Wollongong Local Planning Panel Assessment Report | 13 March 2019

WLPP No.	Item No.1
DA No.	DA-2017/791
Proposal	Demolition of existing structures and construction of a residential flat building comprising 6 apartments
Property	Lots 9 and 10 DP 16350, 7 - 9 Henley Avenue, WOLLONGONG
Applicant	PRD Architects Pty Ltd
Responsible Team	Development Assessment and Certification - City Centre Team (TW)

ASSESSMENT REPORT AND RECOMMENDATION

1 FSR INCLUSIONS- LEVEL
 1 : 200

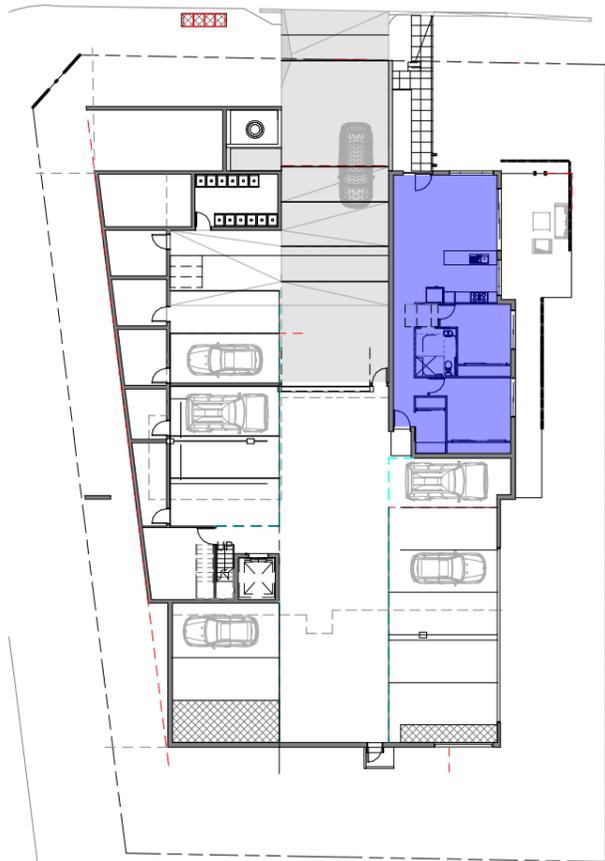
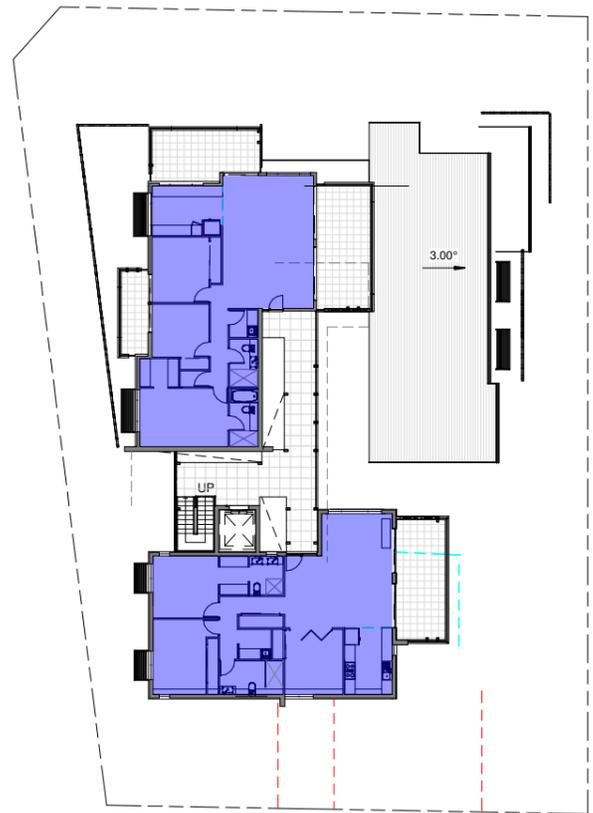
The applicant's GFA calculations indicate that the GFA of the development is 676.3sqm which results in a FSR of 0.5:1. This GFA excludes the area of the internal courtyard which Council considers (at least in part) should be included in the GFA calculations as it is enclosed and partly roofed. The inclusion of this space would result in the FSR exceeding the maximum 0.5:1 and the layout in this regard unnecessarily increases the bulk of the building. It is noted that the applicant responded to this issue through the submission of an amended planning report labelled "Addendum Statement of Environmental Effects". The argument provided in this submission refers to the definition of GFA excluding areas for common *vertical* circulation. The communal circulation space is common horizontal circulation space. The components of the building providing vertical circulation (being the lift and stairs) are excluded from the GFA as per the definition, however it is considered that the first floor communal space is effectively enclosed and therefore GFA.

The inclusion of this space would result in the FSR exceeding the maximum 0.5:1. In any event, as raised by the DRP and confirmed in the planning assessment, the layout of the building and this courtyard area unnecessarily increases the bulk of the building and does not improve the internal amenity of the development. The built form should be contracted and the lobby space condensed to reduce the overall bulk of the building and to resolve other concerns.

DRAWING TITLE
Landscape Concept Plan

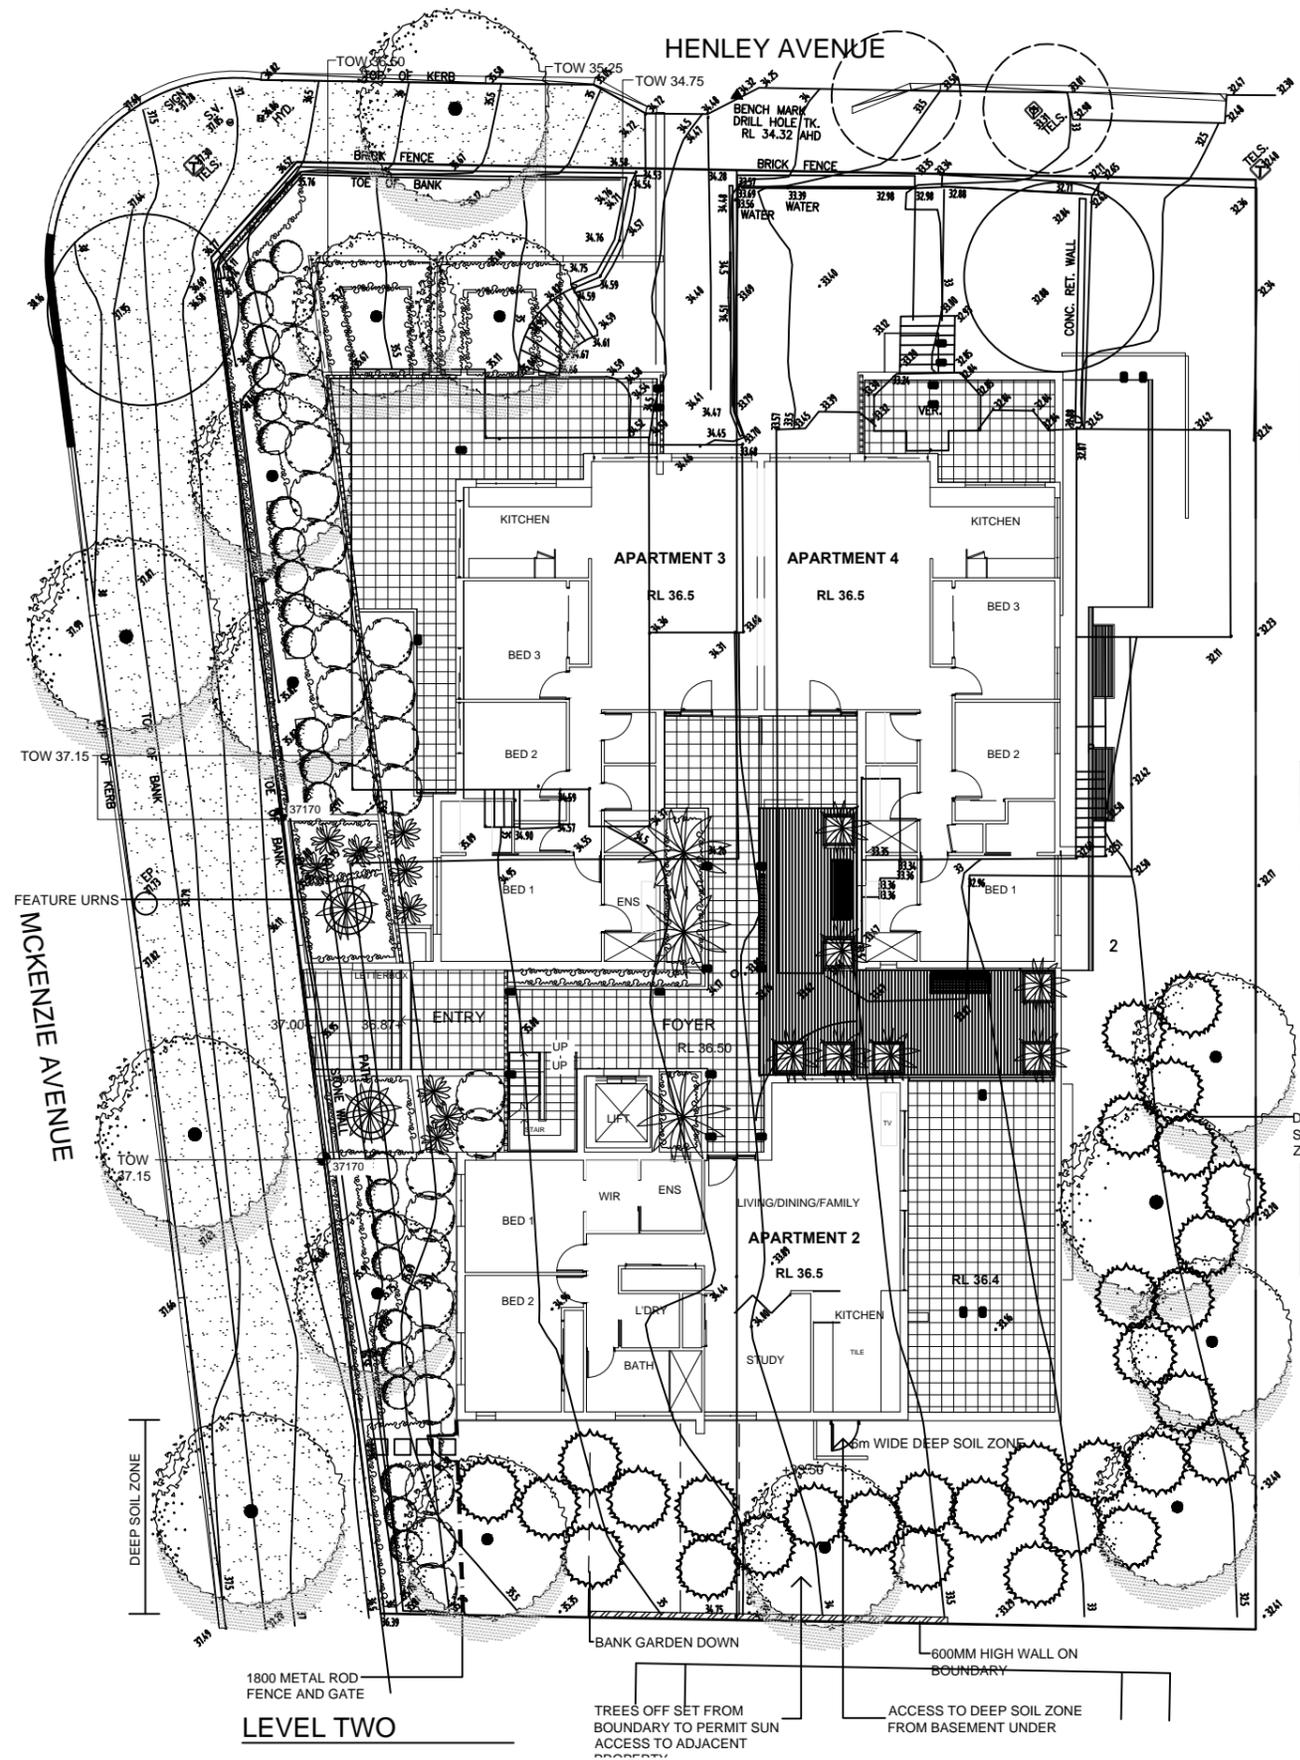
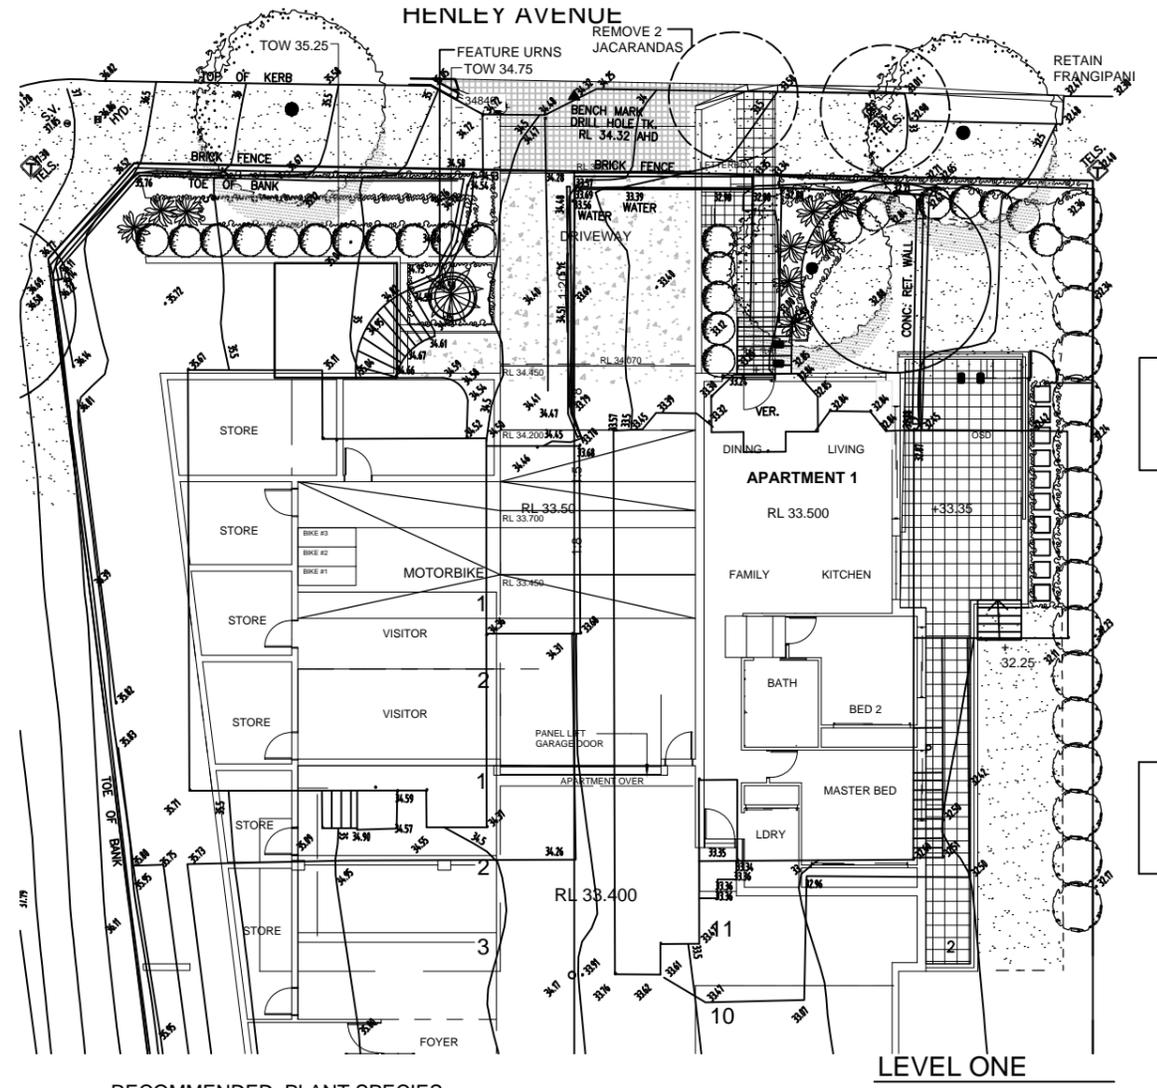
The landscape plans do not align with the most recently submitted architectural plans. At the main pedestrian entry off McKenzie Avenue (and the landscape along McKenzie Avenue to either side of this entry), it is unclear how levels are resolved. The architectural plans show a currently non-existent footpath (the landscape plans do not) but it is unclear if this will be built, and by whom.

"The landscape plans are poorly presented and do not appear to be fully representative of the current scheme nor coordinated well with the built form. Line work from the original survey (objects that are assumed to be removed) are still showing which make this a very difficult set of drawings to review. At the main pedestrian entry off McKenzie Avenue (and the landscape along McKenzie Avenue to either side of this entry), it is unclear how levels are resolved. The architectural plans show a currently non-existent footpath (the landscape plans do not) but it is unclear if this will be built, and by whom.

This entry relies on a solid resolution to the levels within this space and although a section through the entry is provided, the rest of the landscape along this frontage is unresolved. The large walls and bowl planters proposed seem unnecessary and not in keeping with the surrounding neighbourhood. Additional stepped walls along the Henley Avenue frontage appear unnecessary in that the landscape could simply slope with the site.

The entry courtyard between units 2 and 4 is poorly planned and again there are inconsistencies between the architectural and landscape plans. In both versions, COS is bounded by a bathroom and lounge rooms, with windows directly onto the space, and an adjacent balcony without any buffer. The landscape plan shows seating directly outside a bathroom window which raises serious privacy concerns.

The landscape to the south and east of the built form, currently shown as buffer planting, appears to be accessible by a set of stepping stones off McKenzie Avenue but similar to the main entry it is unclear how the levels in this space work and where exactly this path goes. This significant area of landscape could better provide valuable communal open space opportunities rather than how it is currently conceived. Currently it appears to be an unresolved collection of trees with no thought to where windows are, how access works (even for maintenance) or how usable spaces could be created."
